## **PROJECT DESIGN CHANGE SUMMARY REPORT**

### **ADELAIDE WIND ENERGY CENTRE**

**AUGUST 2012**

Client	NextEra Energy Canada, ULC
Contact	Ben Greenhouse
Document No.	1009-CAMO-R-08
Issue	C
Status	Final
Classification	Client's Discretion
Date	17 August 2012

**Figure 3-1: Design Change 1**

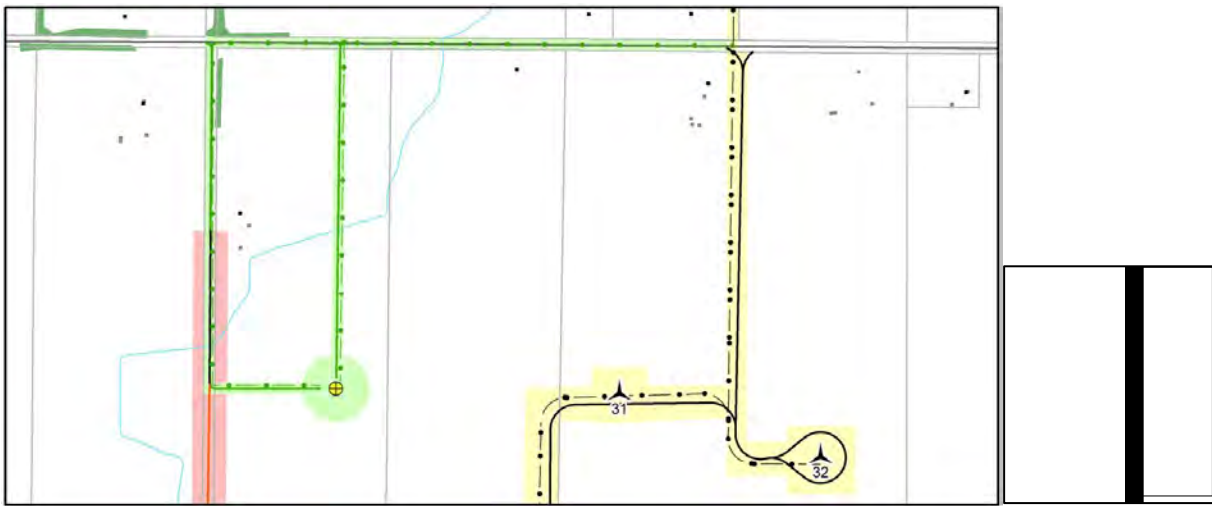
The permanent meteorological tower is located in the southwest section of the Project area. The proposed location is approximately 502 m west of Turbine 31.

At the time the Site plan was released for public consultation the final location of the permanent meteorological tower had not been confirmed. Pursuant to consultation with the affected landowner and the development team a final location has been confirmed.

Figure 3-2: Design Change 2

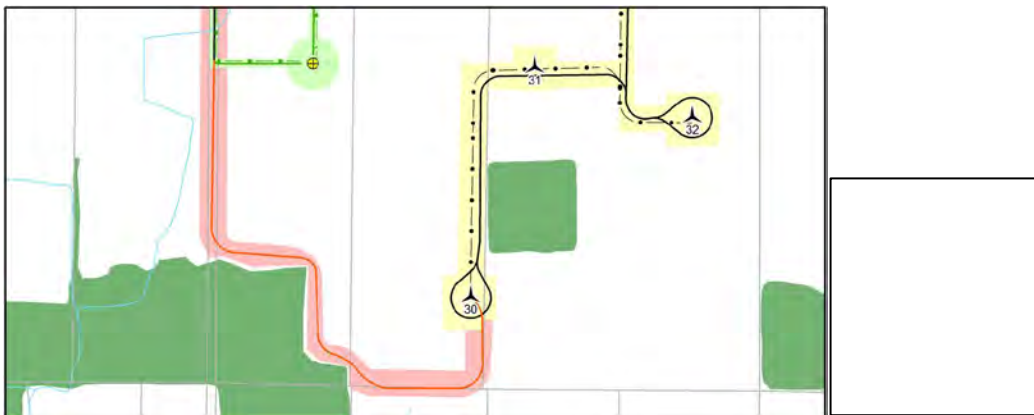
The west access road to Turbine 30 has been removed from the Project layout. Turbine 30 will be accessed via a new access road travelling south from Turbine 31.

Figure 3-5: Design Change 5

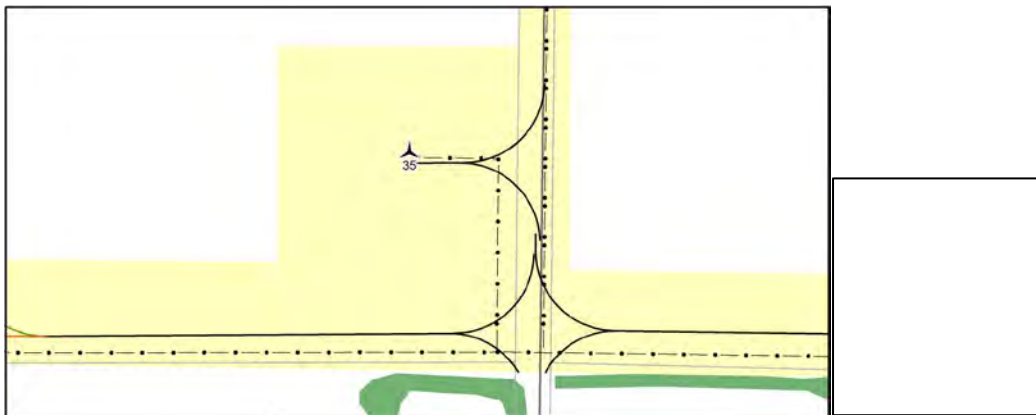
Turbine 35 has been relocated 5 m to the west of the original proposed layout.

**Figure 3-6: Design Change 6**

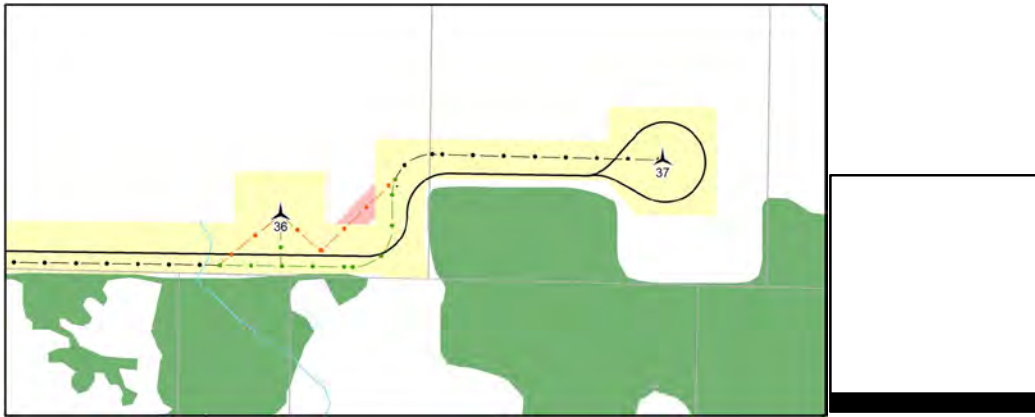
The collector cable from turbine 36 to turbine 37 has been reconfigured to the south to follow the access road.

Figure 3-7: Design Change 7

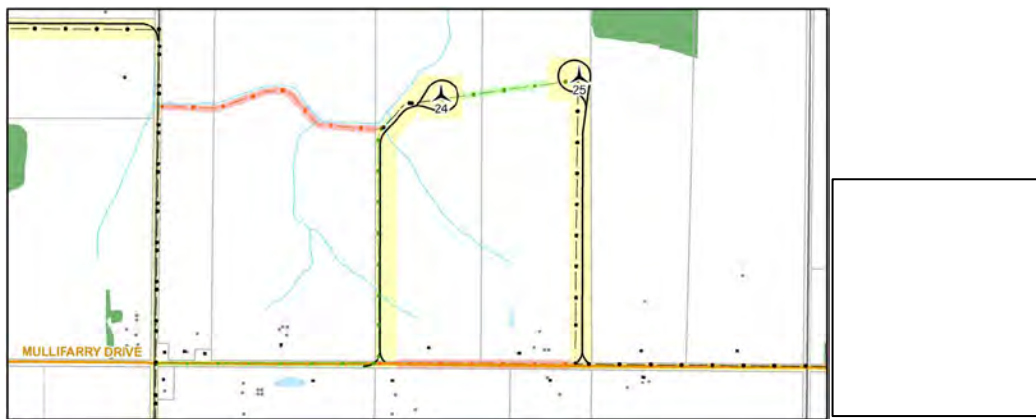
The collector cable from Turbine 24 has been re-configured to travel north from Mullifarry Drive then east to Turbine 25. The collector cable from the original design to Turbine 24, east from Brown Road, has been removed.

**Figure 3-8: Design Change 8**

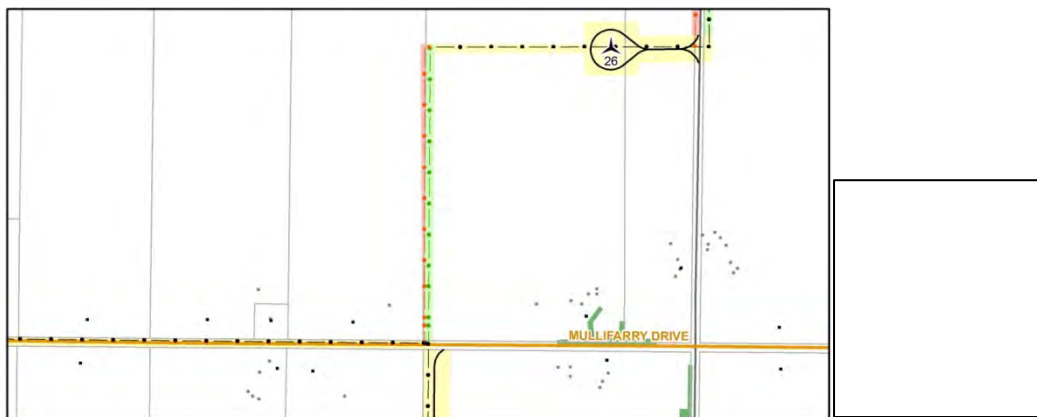
The collector cable from Turbine 26 has been moved approximately 9-13 m to the east of the original proposed location.

**Figure 3-9: Design Change 9**

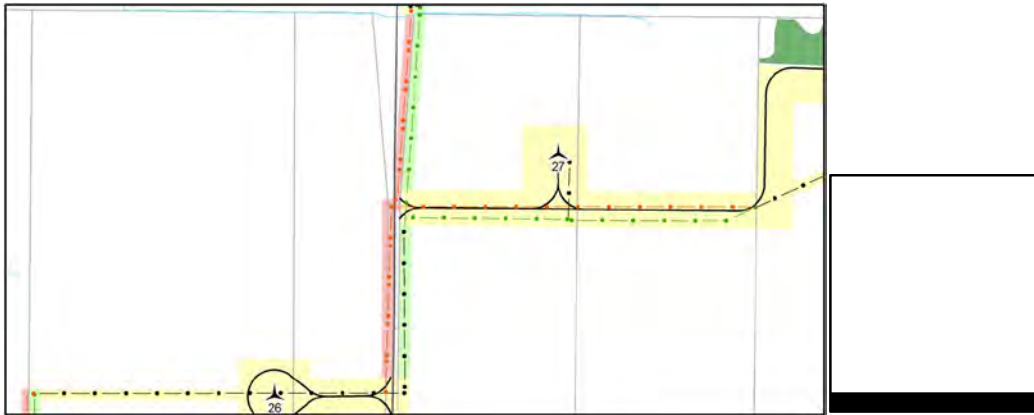
The collector cable from Turbine 27 has been moved approximately 15- 32 m to the east of the original proposed location.

Figure 3-10: Design Change 10

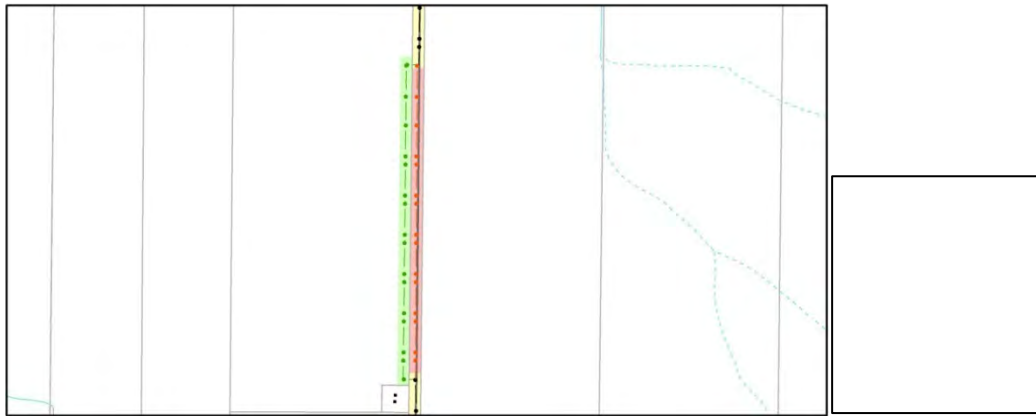
Part of the collector cable for to Turbine 8 has been moved approximately 30 m west of the original proposed location.

Figure 3-11: Design Change 11

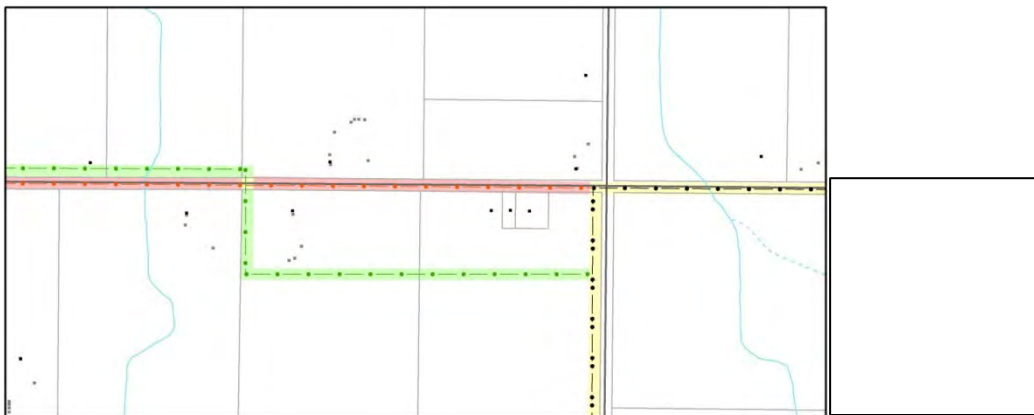
The collector cable from Turbine 4 has been re-located approximately 150 m south of the original proposed location. The cable will run approximately 586 m west in this position along Cuddy Drive.
